Subject: UniStar Nuclear Energy, NRC Docket No. 52-016
Submittal of Response to Request for Additional Information for the Calvert Cliffs
Nuclear Power Plant, Unit 3
RAI No. 36, Revision 0 – Emergency Planning

Response to RAI No. 36, Revision 0

Emergency Planning

Figure J-13. Evacuation Time Estimates – Scenario 13 for Region R03 (Entire EPZ)

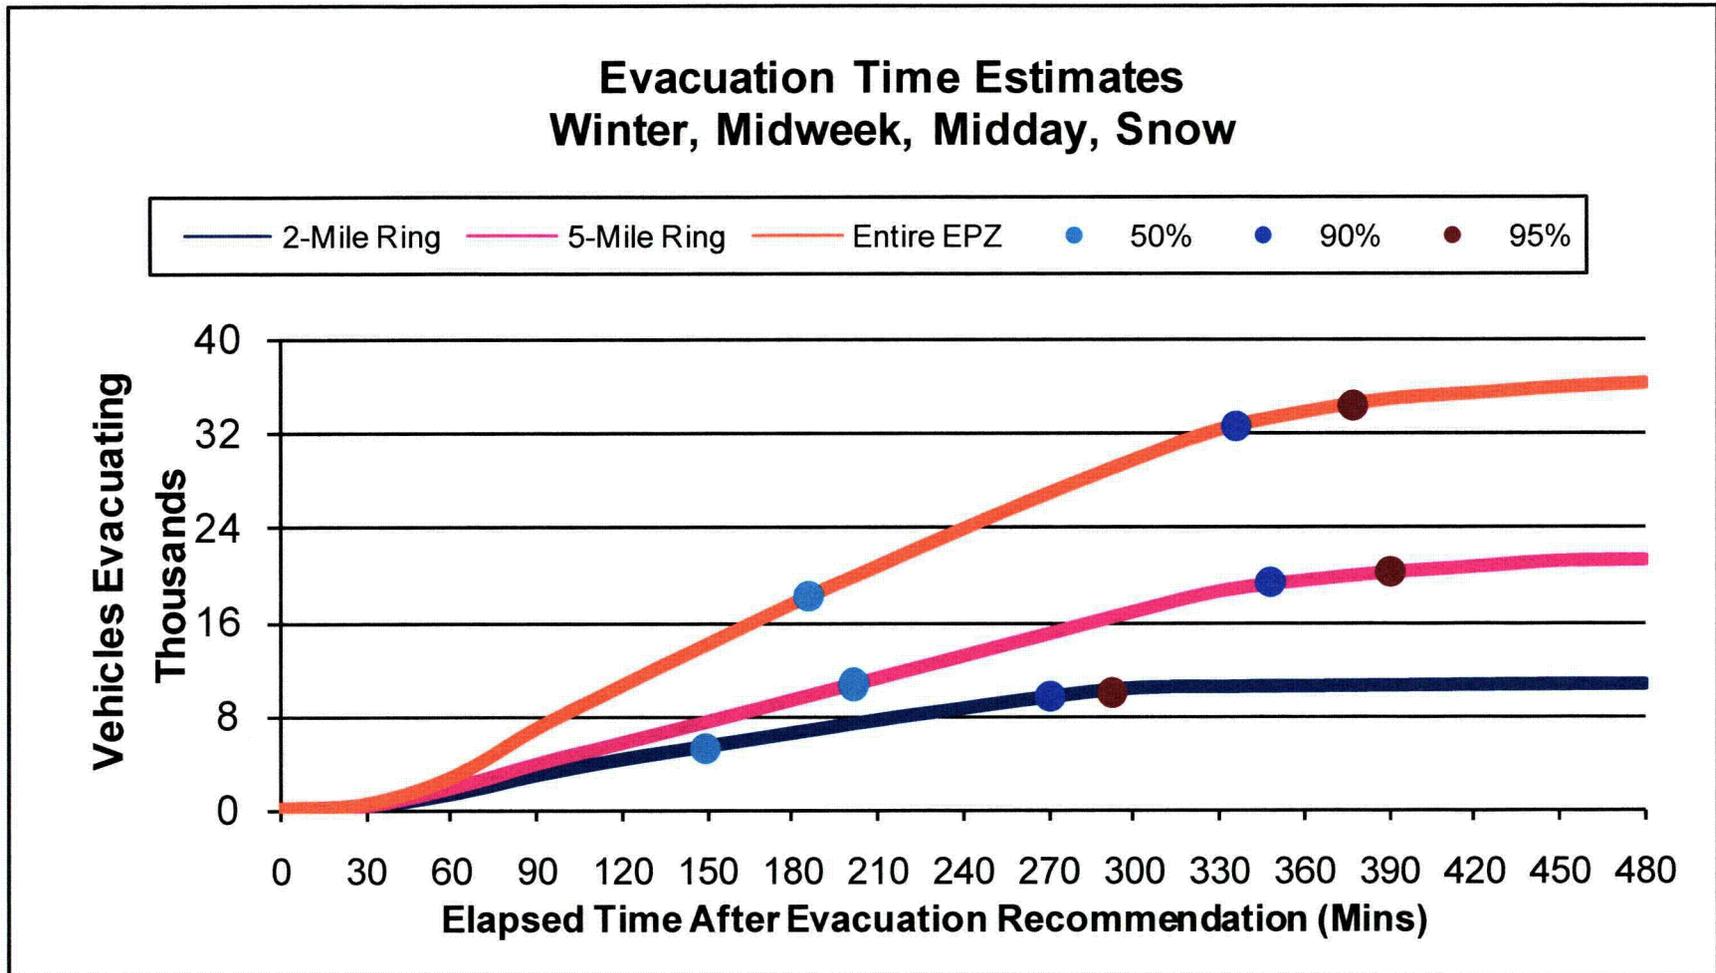
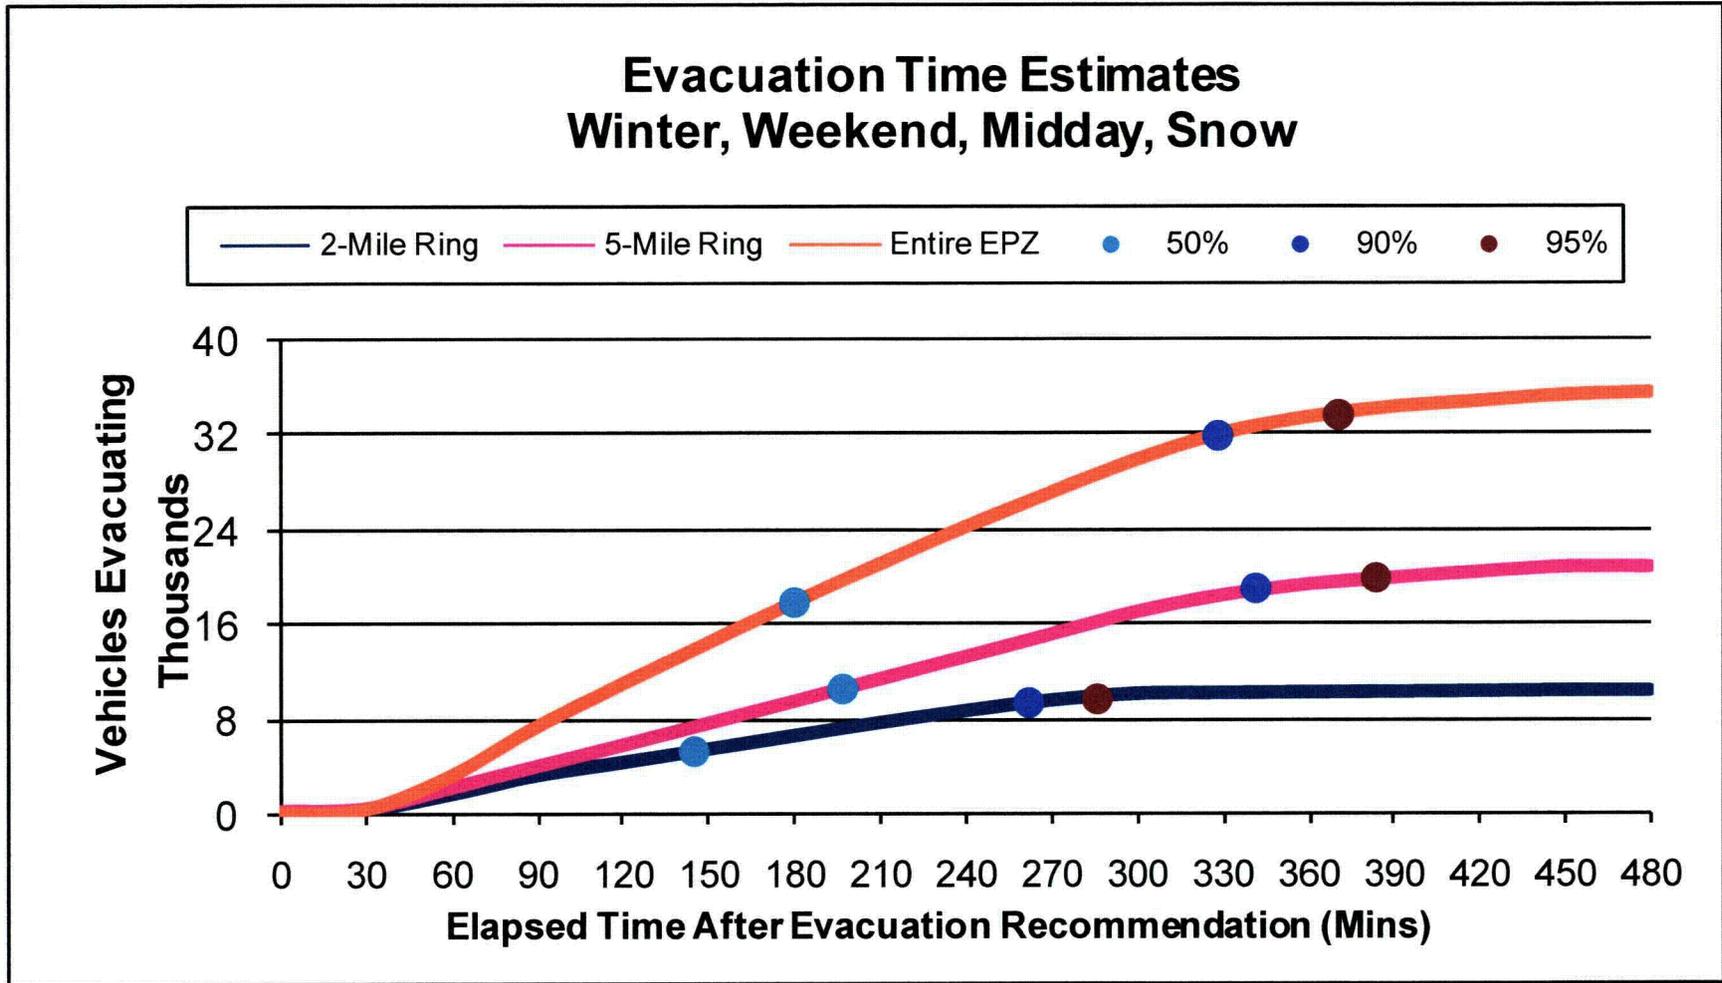
B. In Tables 1-1, "Summary of General Population Evacuation Time Estimates-Summer," (page 1-4) and Table 1-2, "Summary of General Population Evacuation Time Estimates-winter," (page 1-5) the "Preparation Time for Adverse Weather and Total Public Response Time for Adverse Weather" (columns 10 thru 13) are the same between summer and winter scenarios. Explain why there is not a difference between summer and winter preparation times or total response times for adverse weather. Also, discuss the basis for the 30 minute travel time.

Nonetheless, two snow scenarios will be added to a future revision of the ETE report to address the unlikely event that significant snowfall is coincident with an advisory to evacuate the CCNPP EPZ. The capacity and free flow speed on all links in the analysis network was reduced by 20% for these new snow scenarios, also based on the research of Agarwal, et al referenced on page 1 of this response. In addition, the snow removal mobilization time distribution recently obtained from the telephone survey results of the Susquehanna Steam Electric Station (SSES) EPZ was adapted. The telephone survey question asks, "How long would it take you to clear 6-8" of snow to move the car from the driveway or curb to begin the evacuation trip? Assume the roads are passable." Table 5-1 of the 2008 ETE report will be replaced in a future revision of the ETE report with the attached revised table, which includes distributions for snow. The attached

- Tables J-1A, B, C and D – incorporate ETE results of snow scenarios.
- attached figures J-13 and J-14 will be added to Appendix J
